AERONAUTICAL CHARTING FORUM
Charting Group
Meeting 09-02 - October 28-29, 2009

RECOMMENDATION DOCUMENT

FAA Control # 09-02-225

Subject: Charting Special Authorization (SA) CAT I and SA CAT II Approach Procedures

Sample Jeppesen SA CAT I Chart with standard CAT I, 1800 RVR, and SA CAT I mins

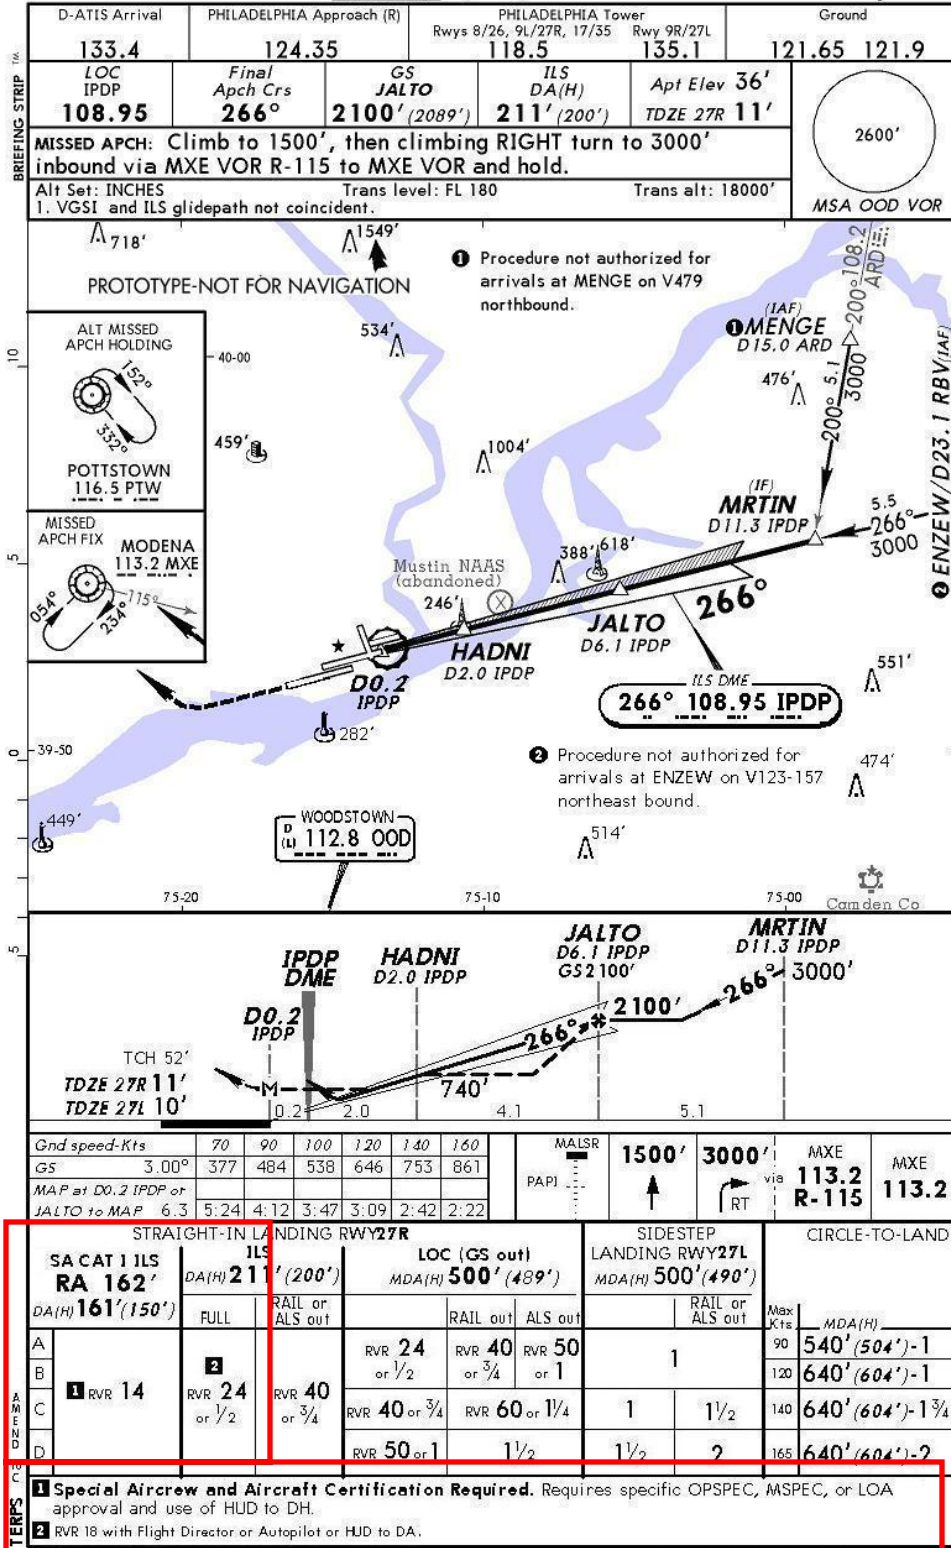
When SA CAT I is charted in this manner, there is great potential for confusion. In many cases, the 1800 RVR chart note will be required in reference to the RVR 2400 minimum, and the SA CAT I chart note will also be required (Requires specific OpSpec, MSPEC, or

LOA approval and use of HUD to DH). Also, the addition of charted CAT II style RA mins in both the minima line and the profile view potentially adds to the confusion.

Sample proposed Jeppesen SA CAT I Chart with only SA CAT I minimum

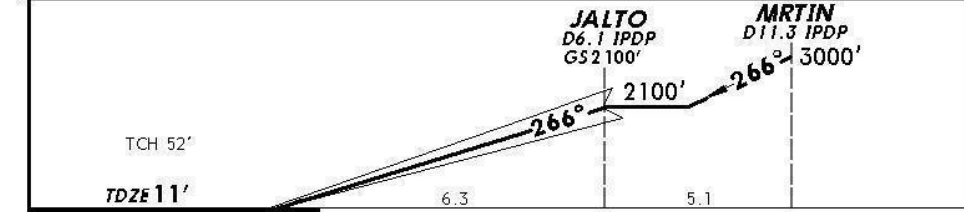
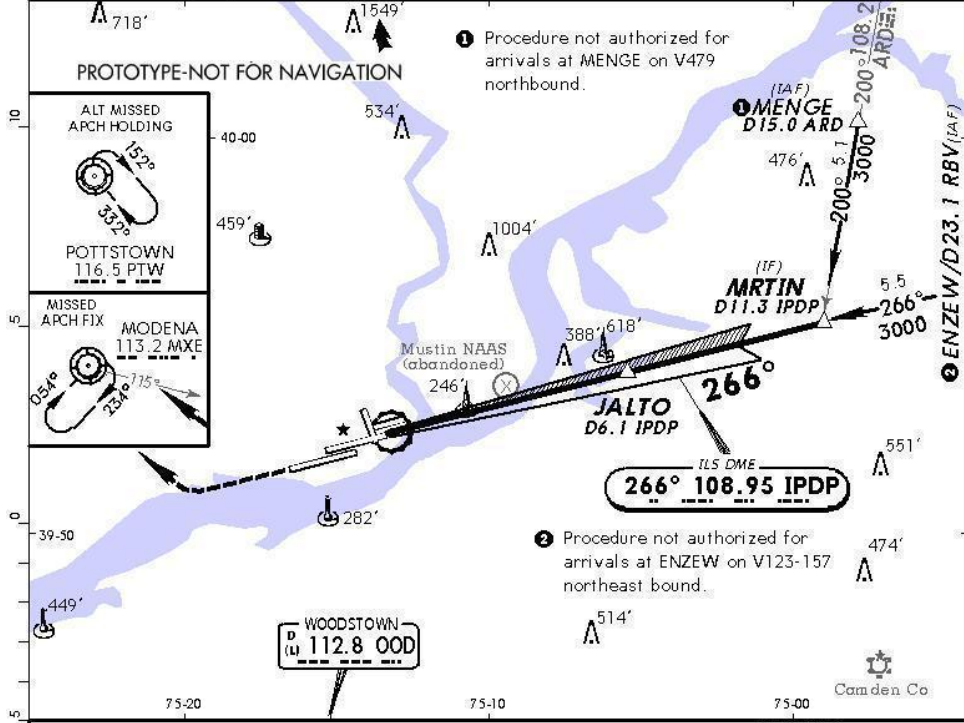
Recommendations: To help simplify all CAT I ILS minimums, and avoid additional lines or additional ILS Z and ILS Y charts, we are proposing a new charting standard for SA CAT I. This chart would be similar to the CAT II/III charts, with a few minor changes:

1. “ILS RWY 27R (CAT II)” is changed to “ILS RWY 27R (SA CAT I)” in the title at the top and bottom.
2. “CATEGORY II ILS – SPECIAL AIRCREW & AIRCRAFT CERTIFICATION REQUIRED” is changed to “SPECIAL AIRCREW & AIRCRAFT CERTIFICATION REQUIRED”
3. Add the chart note “Requires specific OpSpec, MSpec, or LOA approval and use of HUD to DH.” It does not need to be referenced to a specific line of minima since SA CAT I would be the only minimum on the chart.

It was agreed that SA CAT I would not be a part of the title and would be treated the same as CAT II or CAT III for titling and coding purposes; i.e., as a parenthetical.

Sample proposed Jeppesen SA CAT II Chart

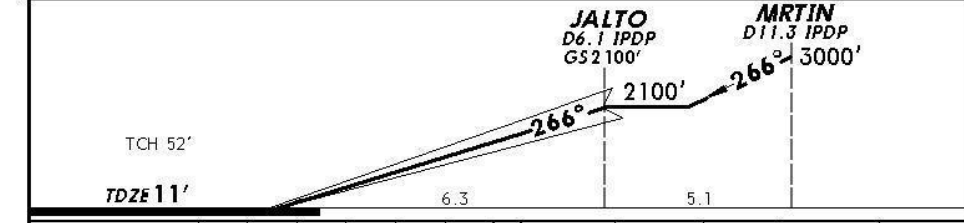
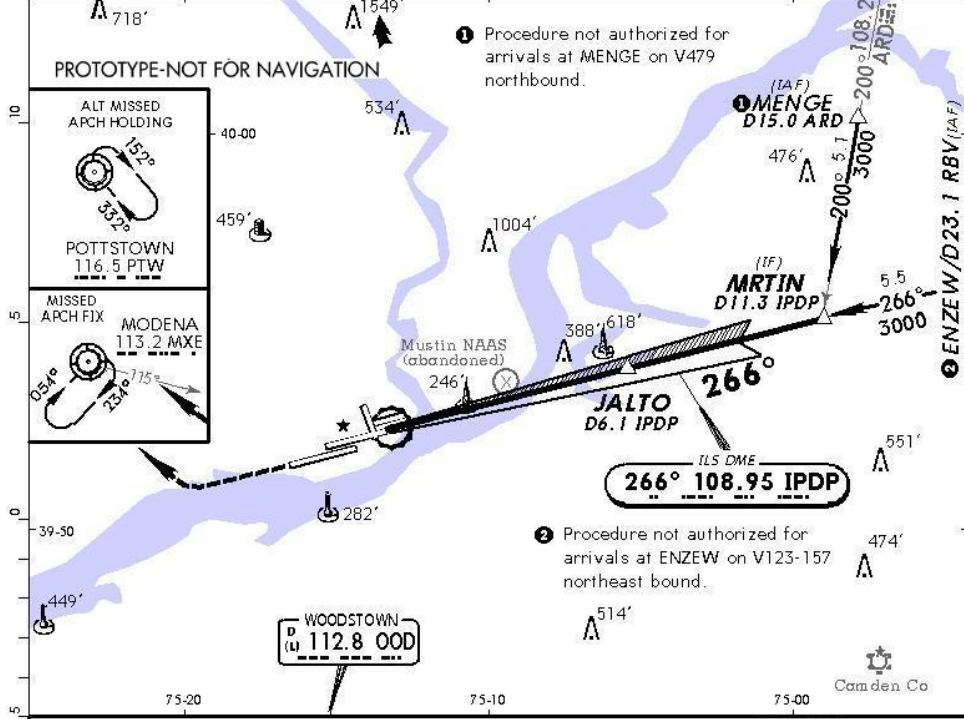
We also proposed a similar change be applied to SA CAT II approaches to help pilots differentiate between SA CAT II and standard CAT II. 8400.13D requires a change to the chart note, which adds the equipment requirement and eliminates the ICAO reference, creating a shorter chart note. The proposed SA CAT II plate would contain the new chart note, and change the chart title from “(CAT II)” to “(SA CAT II)”.

Mr. Brad Rush, FAA/AeroNav Services, expressed concern that the proposed use of the parenthetical (SA CAT II) as a supplement to the procedure title is contrary to accepted ICAO procedure title conventions - which the FAA itself had originally promoted and which ICAO had accepted. Mr. Rush believes that ILS SA CAT I or II procedures should be titled ILS-Z, -Y, and -X procedures.
